Contract #: 04-0120F4Cty: SF/ALA Rte: 80 PM: 13.2/13.9File #: 69.25B**QUALITY ASSURANCE -- NON-CONFORMANCE REPORT****Location:** Changxing Island, Shanghai, PRC**Report No:** NCR-000207**Prime Contractor:** American Bridge/Fluor Enterprises, a JV**Date:** 21-Oct-2008**Submitting Contractor:** Zhenhua Port Machinery Company, Ltd (ZPMC), Changxing Island**NCR #:** ZPMC-0184**Type of problem:**

**Job Name:** SAS Superstructure

**Subject:** NCR No. ZPMC-0184

## NCR PROPOSED RESOLUTION

### Location : 1st Lift East Tower ( Skin E )

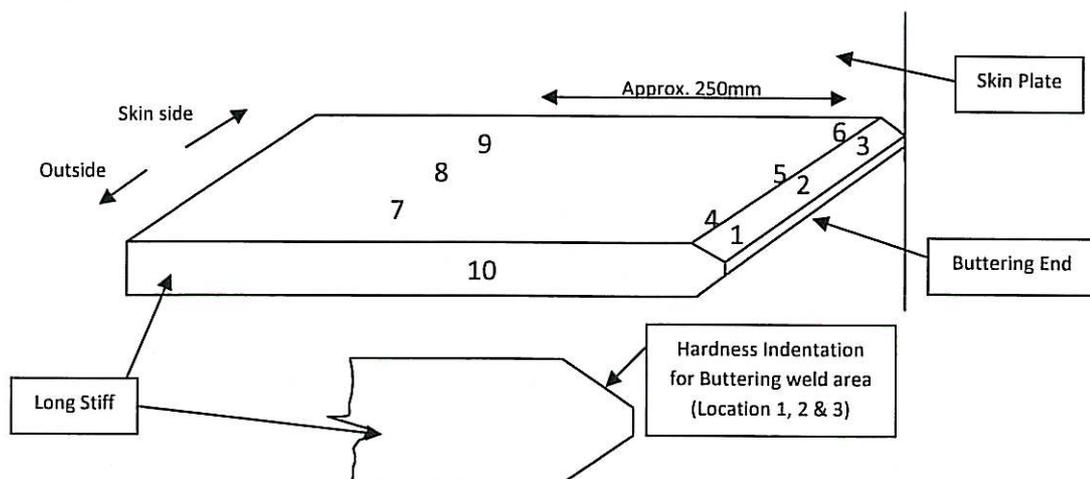
The proposed resolution is not acceptable. There were inconsistencies with the attached hardness testing results, and the hardness sampling locations could not be identified. Please coordinate with the Department's representatives in Shanghai for hardness testing in the presence of the Engineer.

# Hardness Testing Lift 1, East and South Shaft

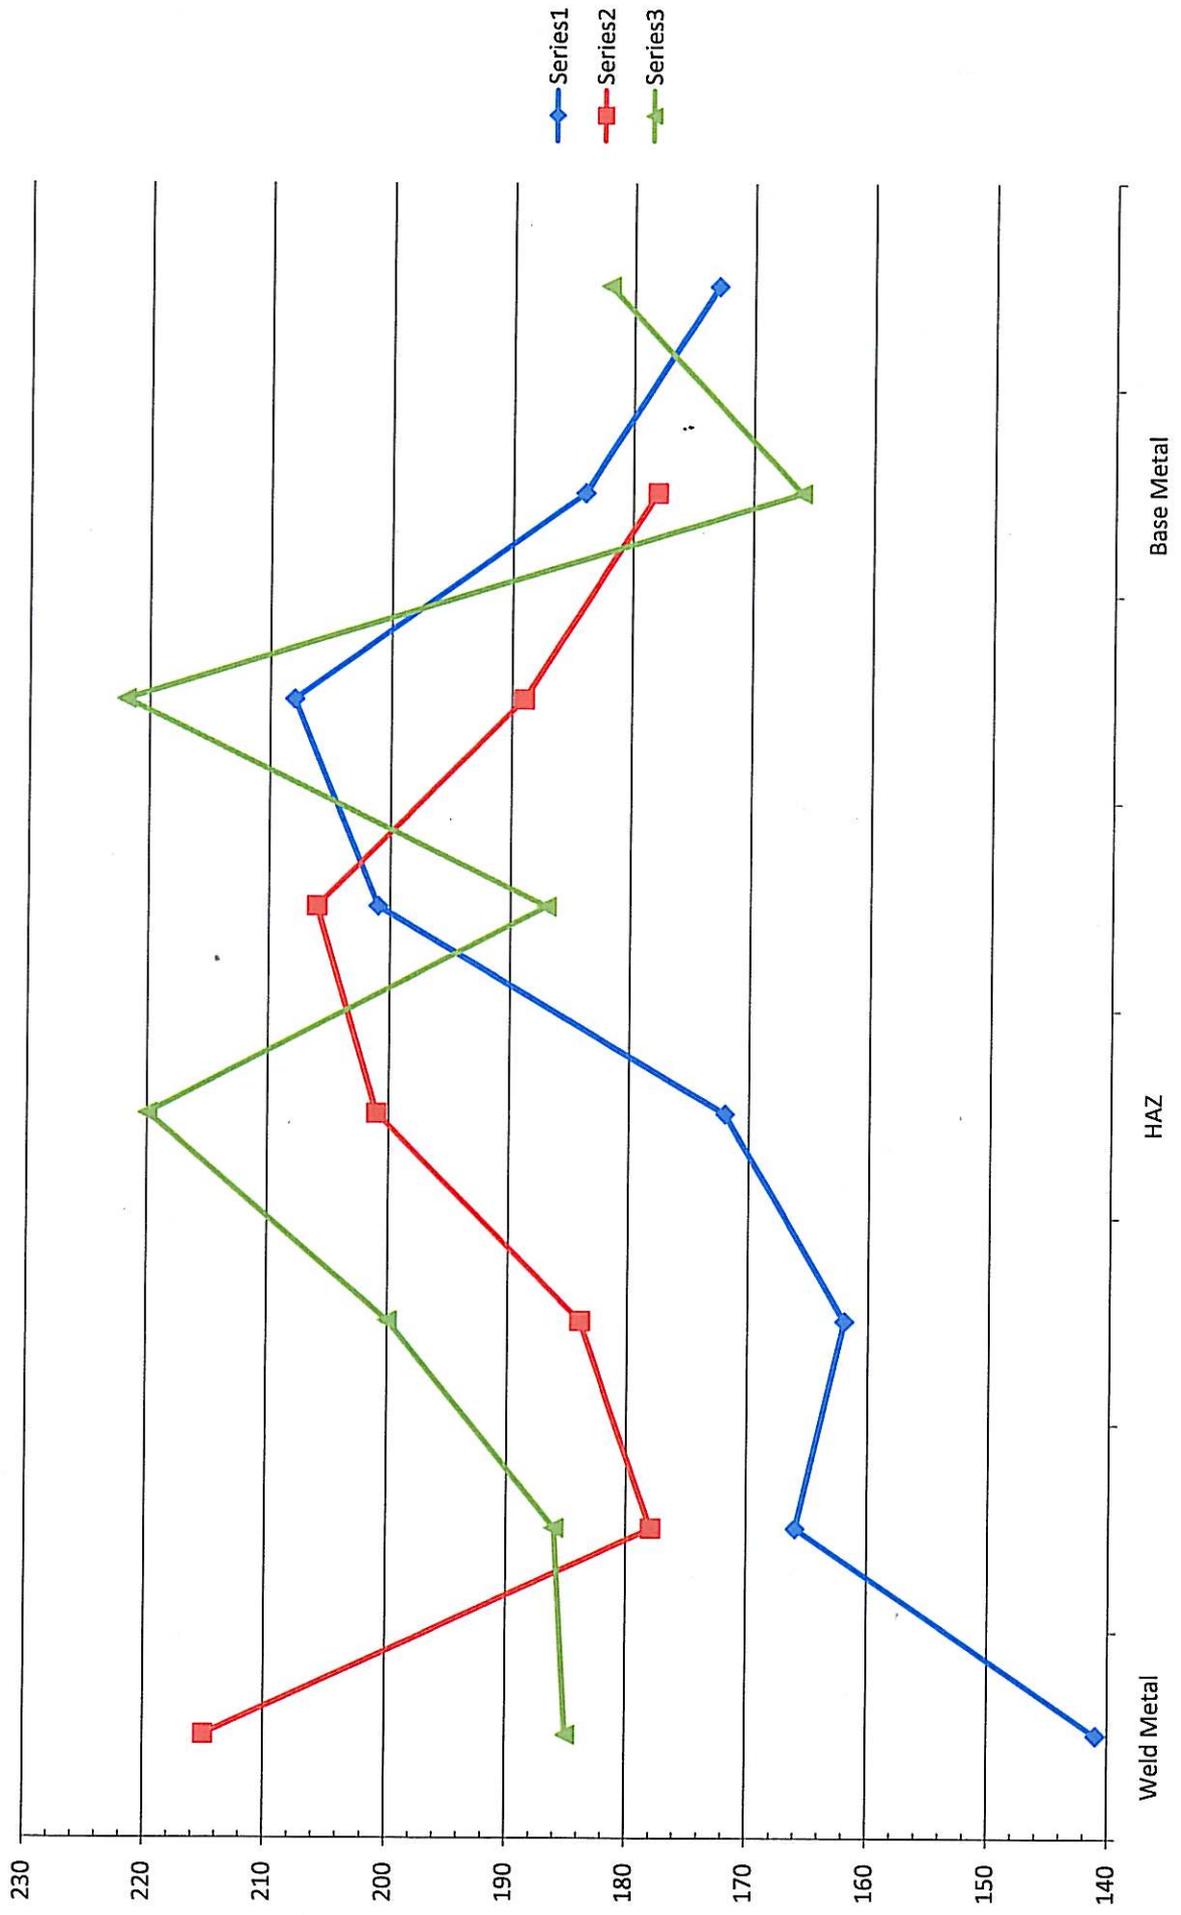
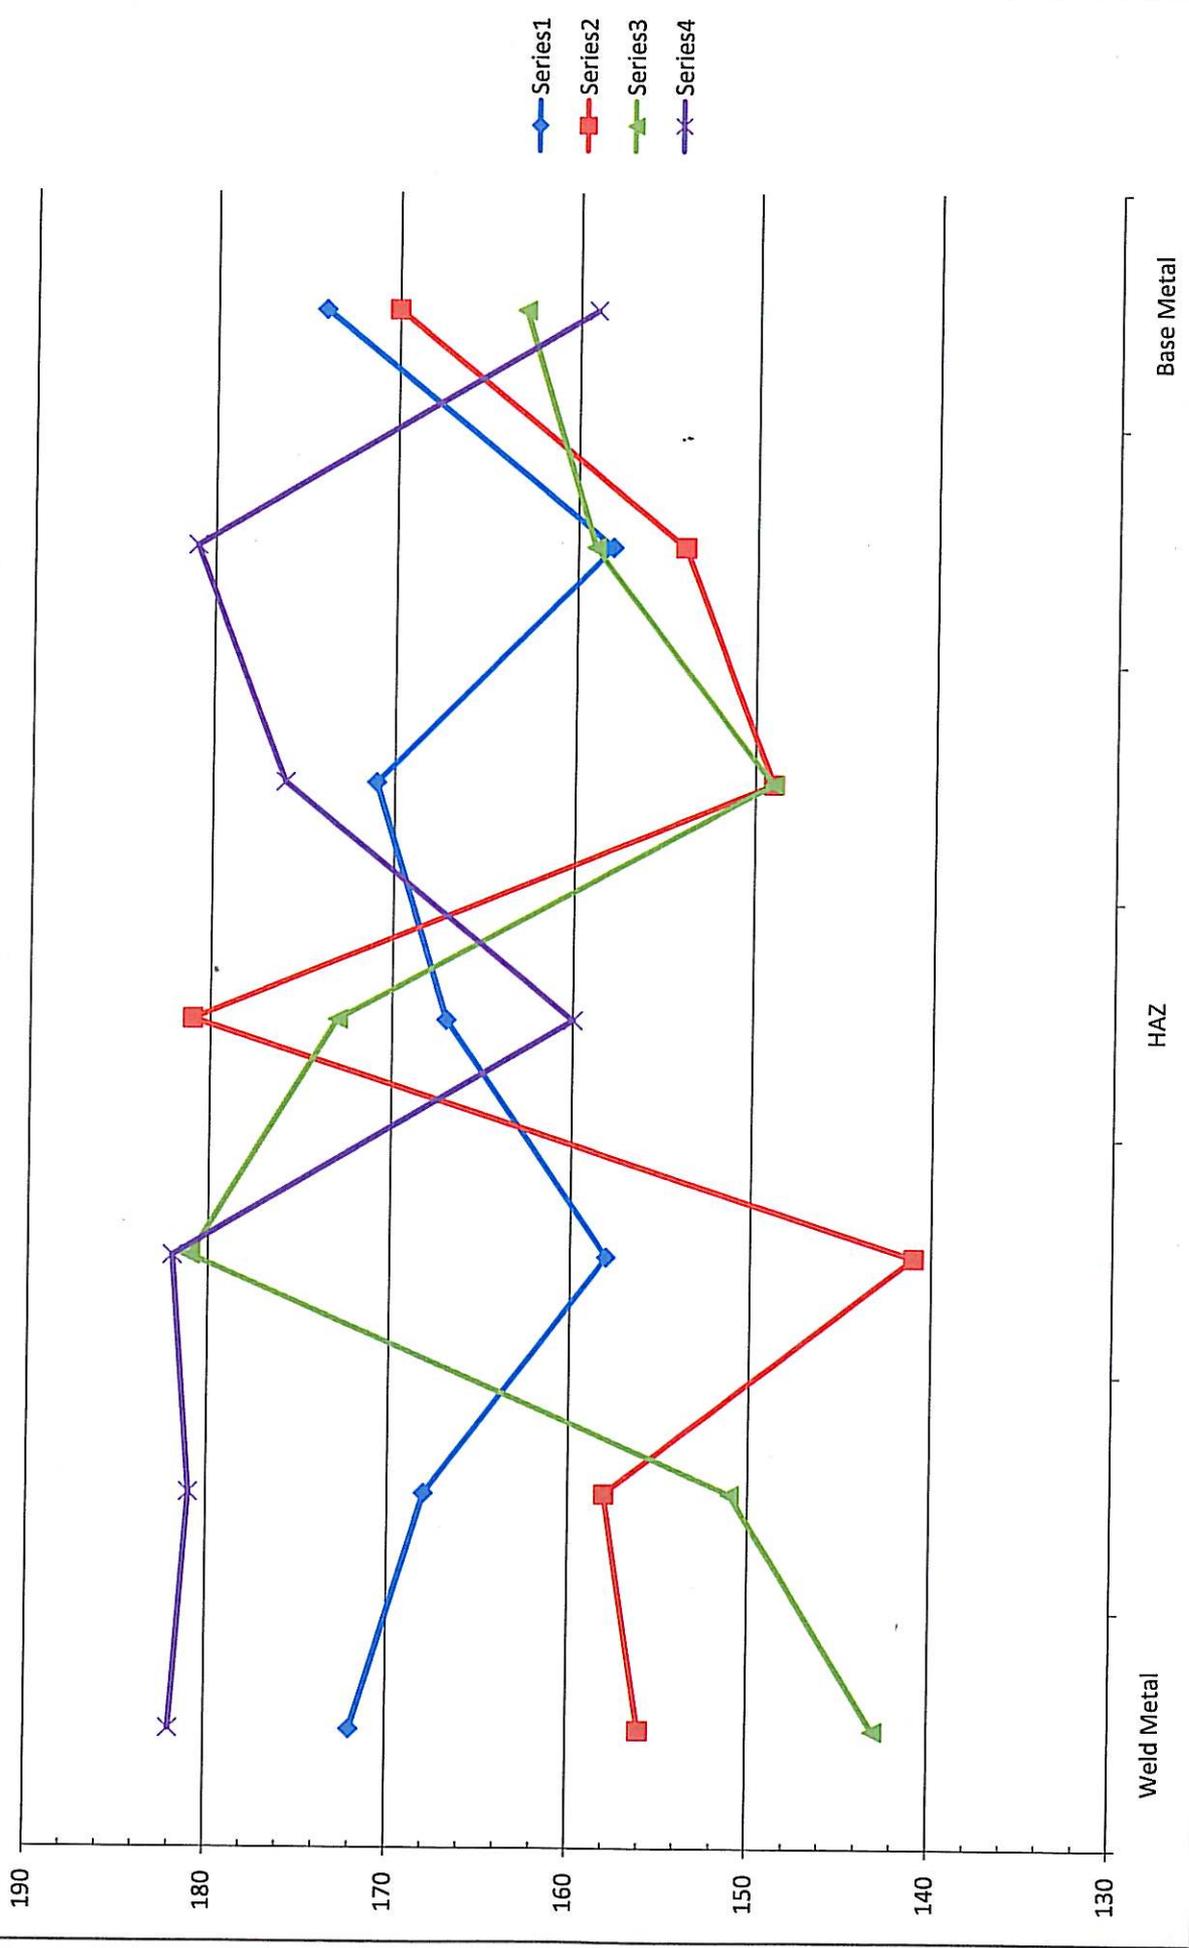
**Reference Resolution:** Attached are the locations of hardness testing in Lift 1 of the South and East shafts in built up areas. ZPMC requests closure of the NCR based on the submitted documentation.

Attached are the locations of hardness testing in Lift 1 of the South and East shafts in built up areas. Contained in the attachment are pictures of the methodology and equipment used to gather the data. ZPMC requests closure of the NCR based on the submitted documentation.

Based on the submitted documentation and verbal clarification from the ABF JV representative during the regularly scheduled weekly Tower Meeting, the proposed resolution is acceptable.

The Department concurs that Non-Conformance ZPMC-184 is closed.
